Site Plan Review Committee (SPRC)
Staff Report for
3033 Wilson Boulevard (Clarendon Square)
SPLN24-00003

3033 Wilson Blvd (SPLN24-00003)
Clarendon Square
(RPC #15-067-002, -003, -005, -006, -007, -033, -036)

SITE PLAN REVIEW COMMITTEE**DATE:** December 5 – December 15, 2024**PLACE:** Online Engagement Opportunity**SPRC STAFF COORDINATOR:** Matthew Pfeiffer**Item 1. 3033 Wilson Blvd. (SPLN24-00003)**

Figure 5. General Land Use Plan Designation

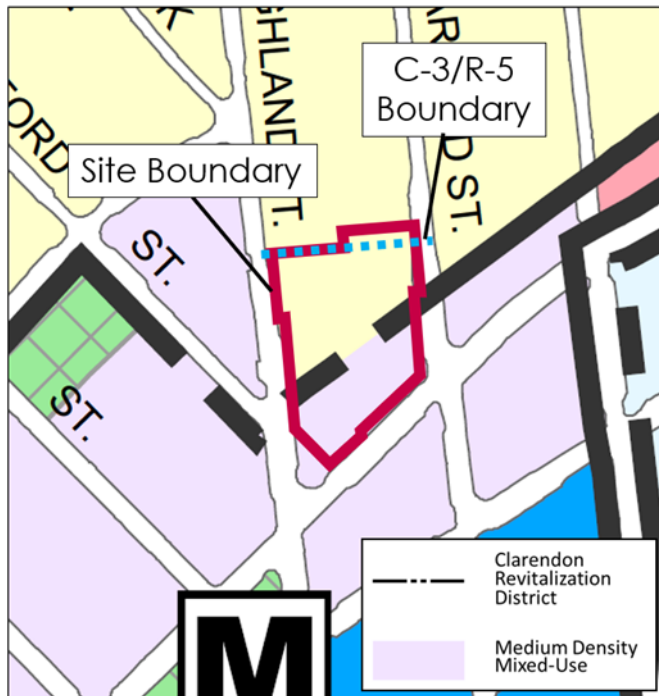
GLUP and proposed GLUP Amendment: The current GLUP designation of the site is split: Approximately the southern half of the site is located within the boundaries of the Clarendon Revitalization District, and is designated “Medium Density Mixed Use”. The GLUP category “Medium Density Mixed Use” is defined as “up to 3.0 FAR with special provision for additional density in the ‘Clarendon Revitalization District’ (see note 12). The northern half of the site is designated “Low Residential 1-10 units/acre.”

Concurrent with the proposed site plan, staff intends to bring forward an amendment to the General Land Use Plan (GLUP) Map, for consideration by the Planning Commission and County Board. The proposed GLUP Map amendment would extend the “Medium Density Mixed Use” designation and the Clarendon Revitalization District boundary to the property lines of the existing Clarendon Square development, including both the portion of the area currently zoned C-3 and the 2,712-square-foot portion of the site proposed for rezoning from R-5 to C-3. The GLUP Map is intended to be general in nature, and the boundary line between Mixed Use/Commercial and Residential land use designations north of Wilson Boulevard between North Highland Street and North Adams Street is roughly parallel to Wilson Boulevard, rather than following property or zoning district lines.

Figure 11. Rear Setback area

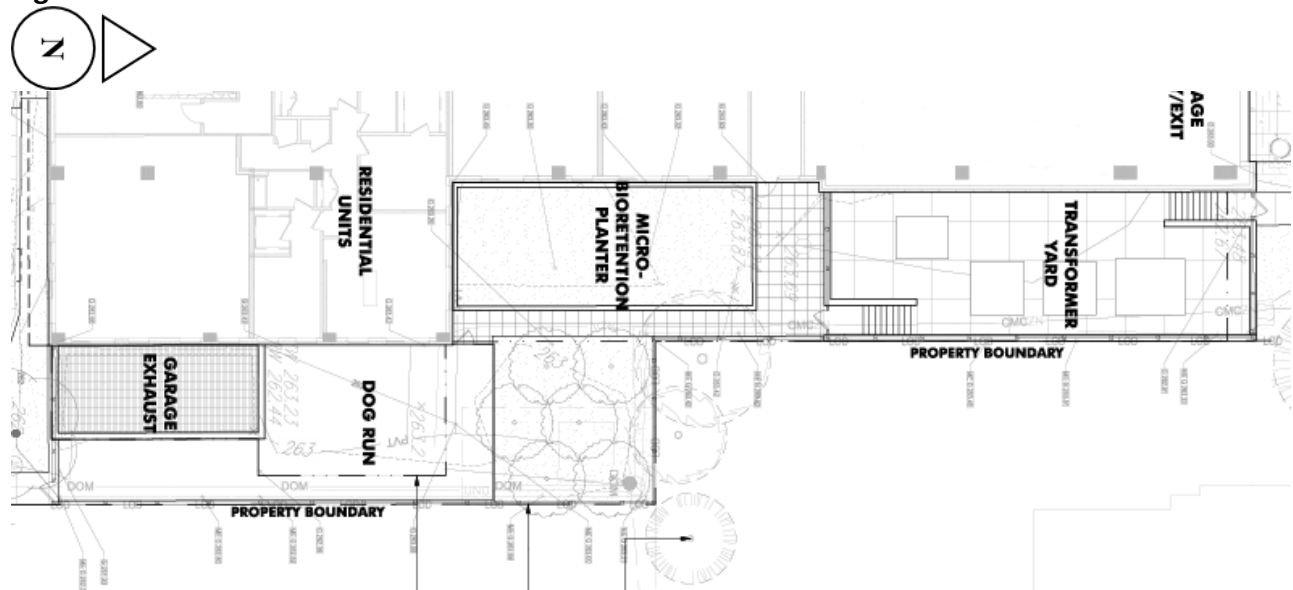
The face of the building is about 23 feet from the rear property line, which is shared with the single family detached houses. In this rear setback the developer proposes service elements such as above grade transformers, a bioretention planter, and a dog run.

In the setback between the building and the single family area, planting is limited to the bio retention planter and a small cluster of ornamental trees.

Figure 19 - Proposed North Highland Street Cross Section

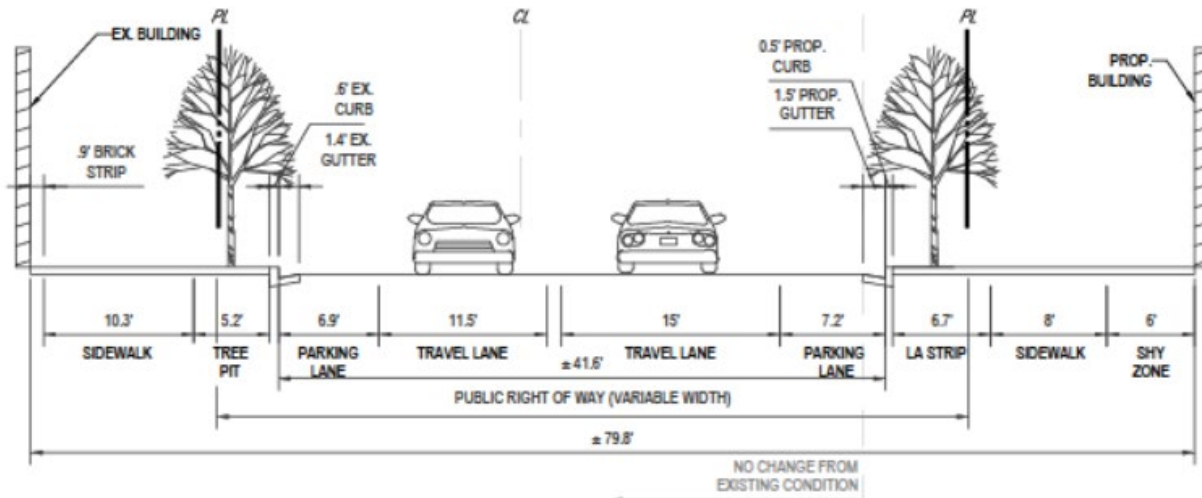
The existing street section for North Highland Street varies across the project's frontage. At Wilson Boulevard the street is wide enough to support three travel lanes (two [2] southbound and one [1] northbound) and parking on both sides of the street. North of North Hartford Street's intersection with North Highland Street the street narrows, with a single travel lane in each direction with on-street parking on both sides of the street. Along the project's frontage the current streetscape varies in size, but it is 15 feet wide or wider. The Clarendon Sector Plan does not have specific recommendations for the curb-to-curb street width of North Highland Street. However, it does recommend a minimum 18-foot wide streetscape including an 8-foot clear sidewalk, 6-foot tree planting and furniture zone with a 4-foot café zone. The project is not proposing any substantive modification to the configuration of North Highland Street, providing the same number of travel lanes as exist today along the project's frontage. The streetscape is proposed to vary along the project's frontage of North Highland Street, and it will meet or exceed the sidewalk, street tree and café zone recommendations of the sector plan.

Figure 20 - Proposed North Garfield Street Cross Section

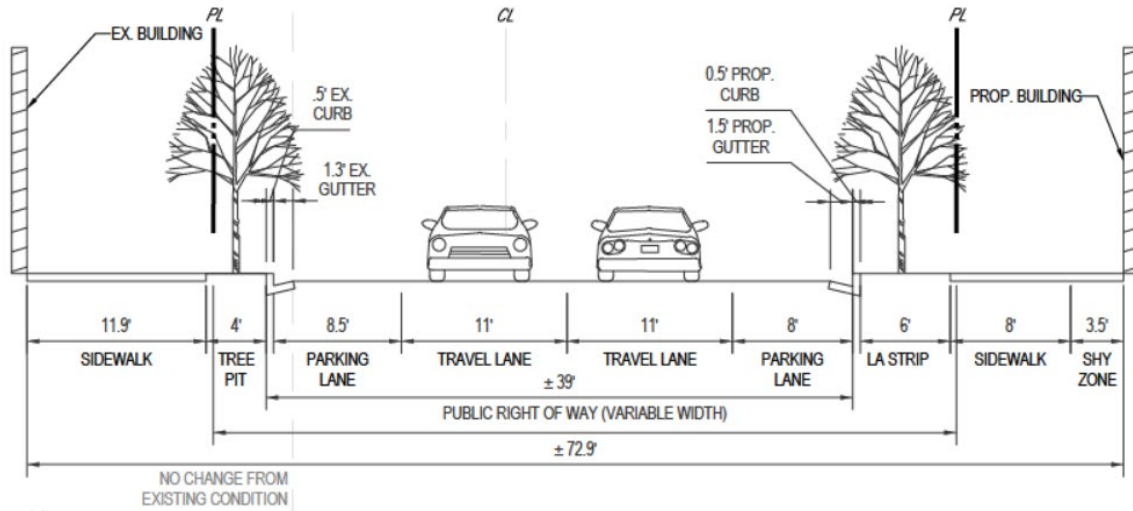
The street section for North Garfield Street varies across the project’s frontage with the curb-to-curb width sides approaching Wilson Boulevard at approximately 45-feet wide. The street supports a single travel lane in each direction, with on-street parking on both sides of the street. The current streetscape is only about 10-feet wide along North Garfield Street providing about 4.5 feet for street trees and about 5.5 feet of clear sidewalk. The Clarendon Sector Plan does not have specific recommendations for the curb-to-curb street width of North Garfield Street. It does however recommend a minimum of a 14-foot wide streetscape including an 8-foot clear sidewalk, 6-foot tree planting and furniture zone. A café zone is not envisioned within the North Garfield Street streetscape as part of the sector plan. The project is proposing a more uniform curb-to-curb street cross section for North Garfield Street at approximately 39-feet. This width provides 11-foot travel lanes in each direction and on-street parking on both sides of the street. The streetscape is proposed to exceed the recommendations of the Sector Plan,

providing an 8-foot clear sidewalk, a 6-foot tree planting and furniture zone with a 3.5-foot shy zone along the building.
